**RE: November 3, 2021 Meeting  
64 Vaughan Mall Restoration  
Portsmouth, NH 03801**

Attention: Historic District Commission  
RE: 64 Vaughan Mall (LU-20-214)

**Re: 64 Vaughan Mall**  
***East Wall of existing building***

2nd Floor perspective  
of floor assembly &  
masonry wall (North  
East Facade) pulling  
away. 3" bow in wall  
shown.

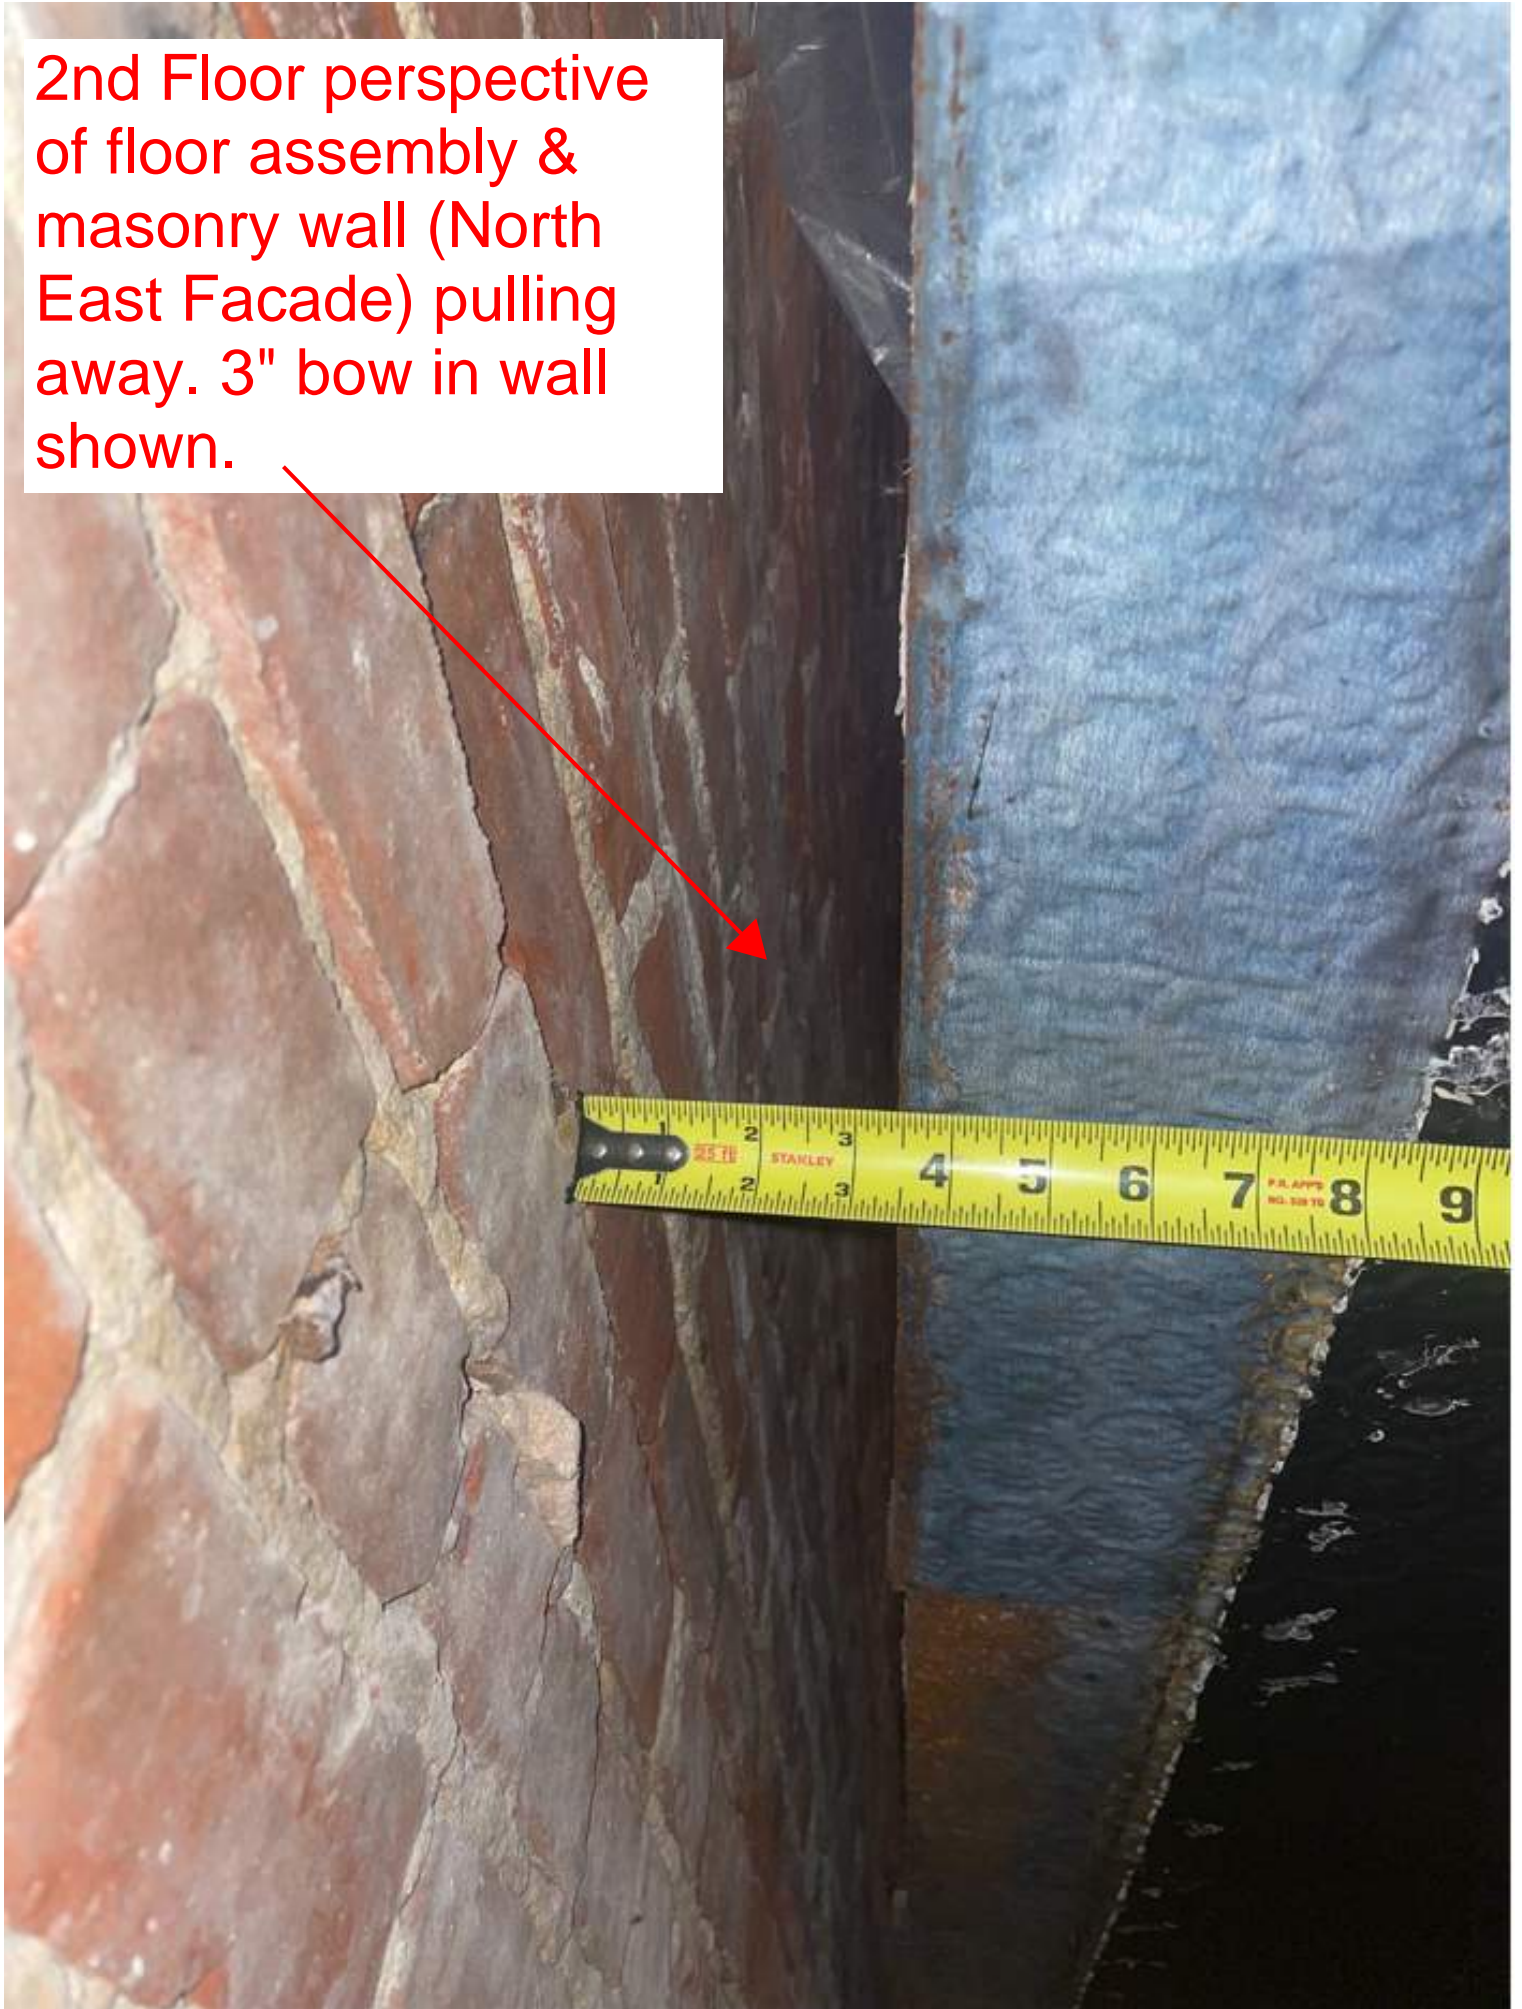
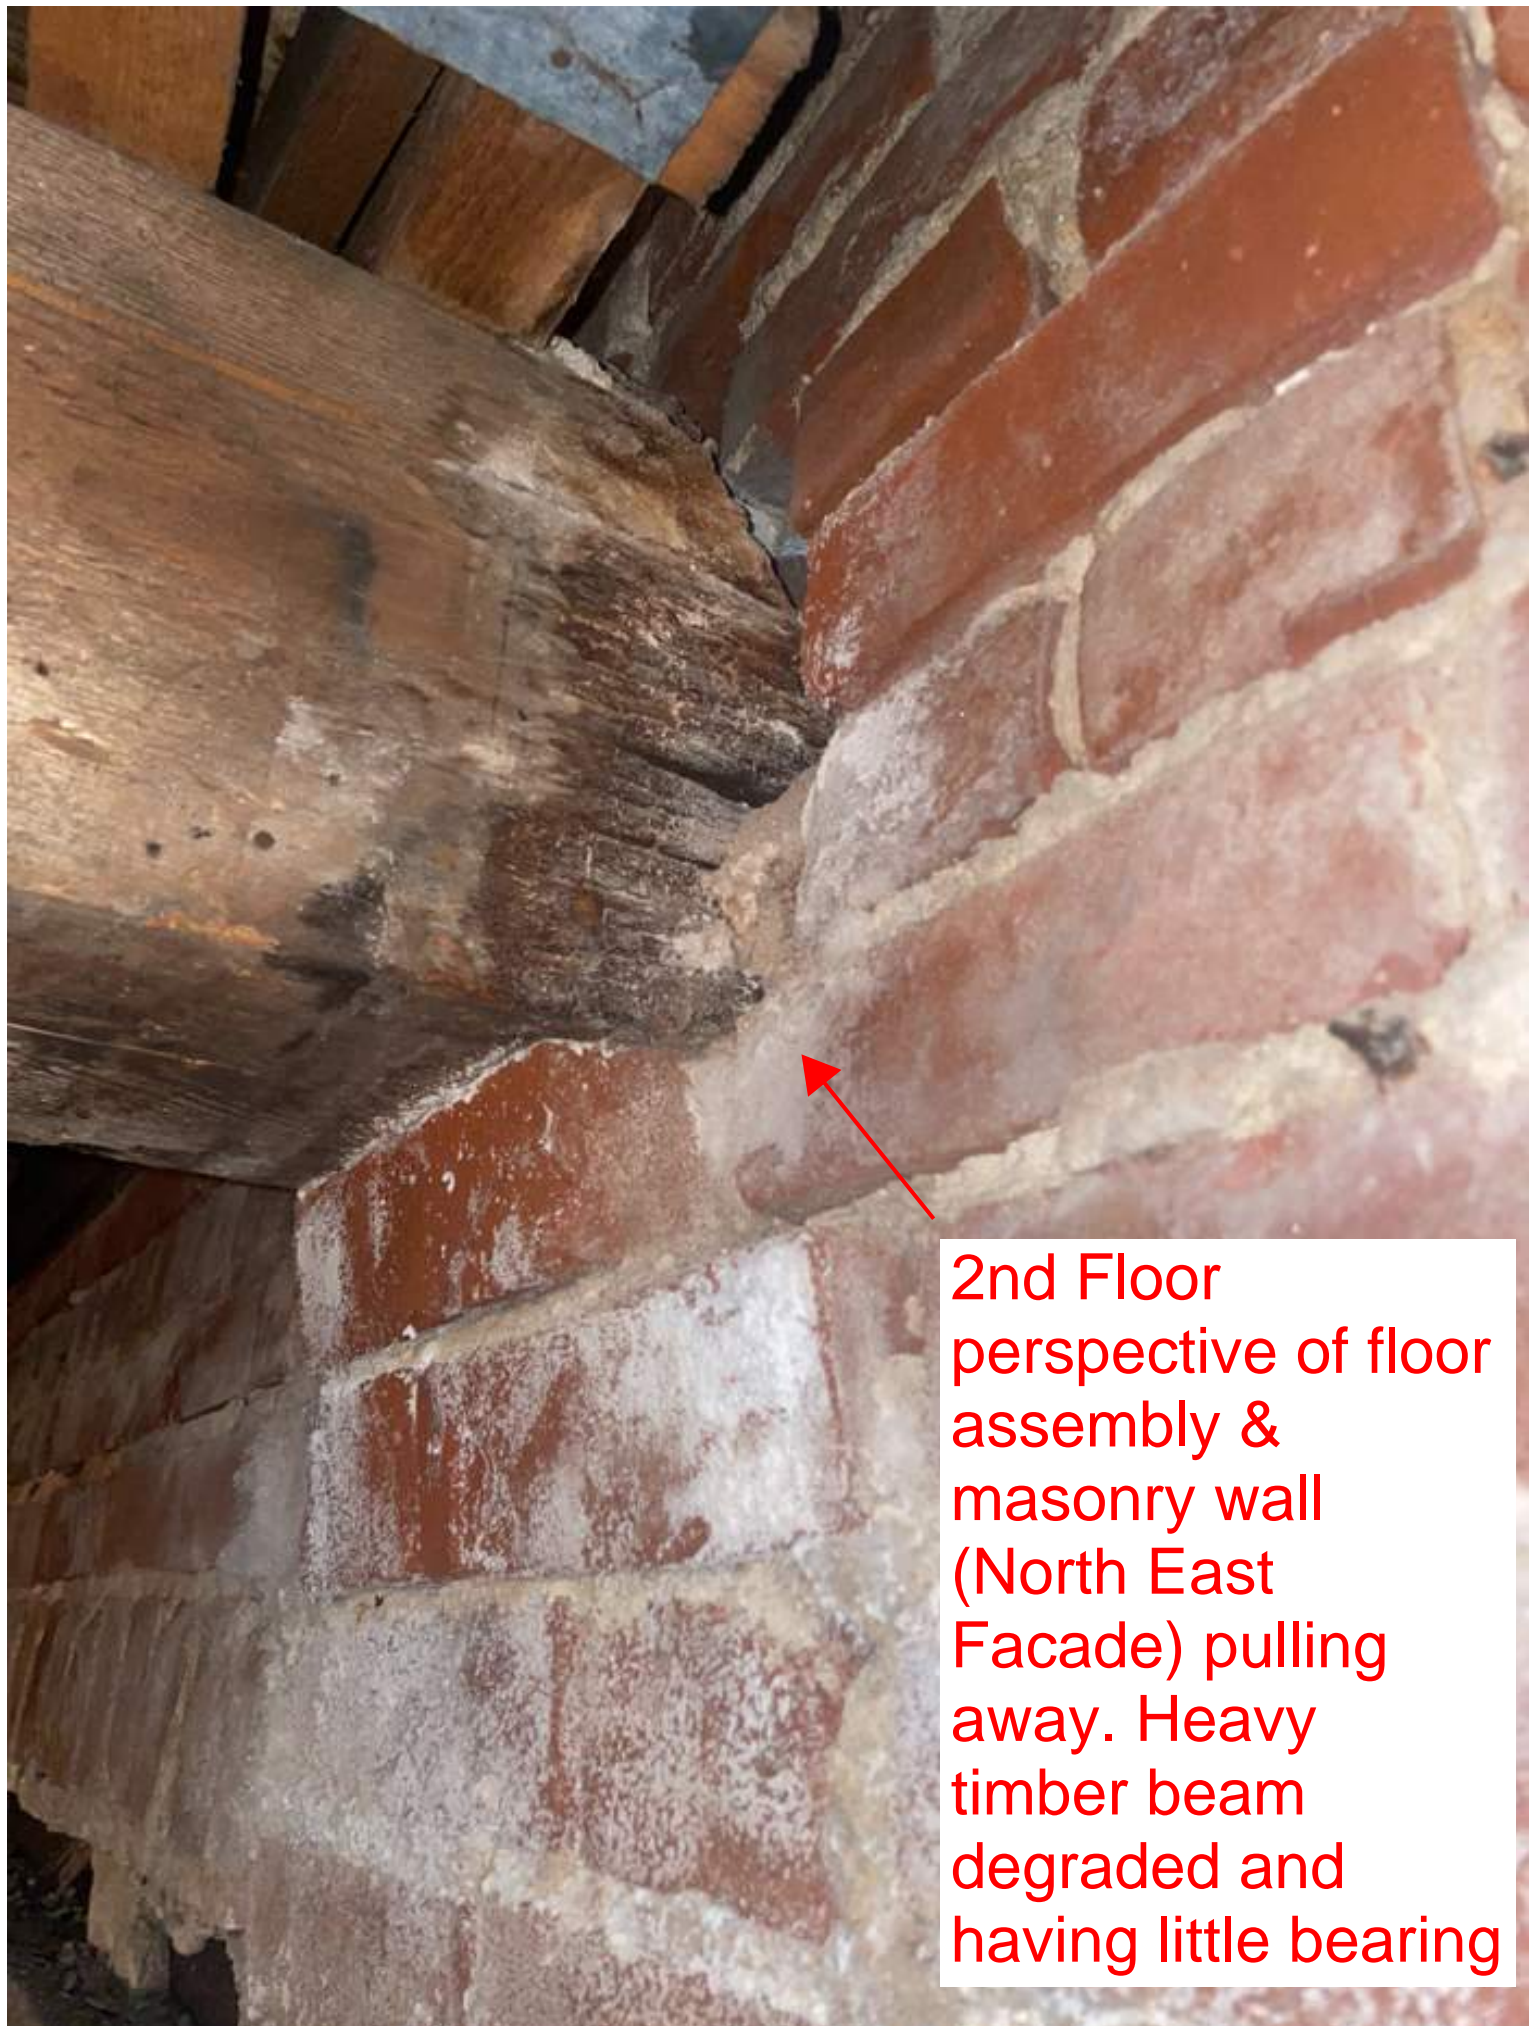
This letter is specifically regarding the existing East wall. This wall is a storefront at street level and a 12" brick wall with windows above. There are serious structural concerns with the north half of this wall. First, from the inside we noticed this brittle unreinforced brick wall has bowed outward approximately 3" and the beam penetrating and bearing on it has very little bearing. As you started to remove the outer wythe from the top down, we further discovered the poor quality and degradation of the wall. Interior joints are poorly mortared with many openings in joints, meaning there is not much effective "glue" holding it together. In addition, we have found some of the steel lintels are severely corroded. This renovation is timely as a structural collapse of this wall was certainly a risk.

Due to the large bow of the wall, and the additional construction quality and deterioration issues, I would strongly advise removal and replacement of the East wall.

The south portion of this wall can be saved. The intent is to remove the outer wythe, clean all loose material, and parge with a fiber reinforced structural coating. Then an abundance of heavy gage galvanized ties will be screwed to the brick to tie back the new outer wythe, which will be mortared tight to the backup.
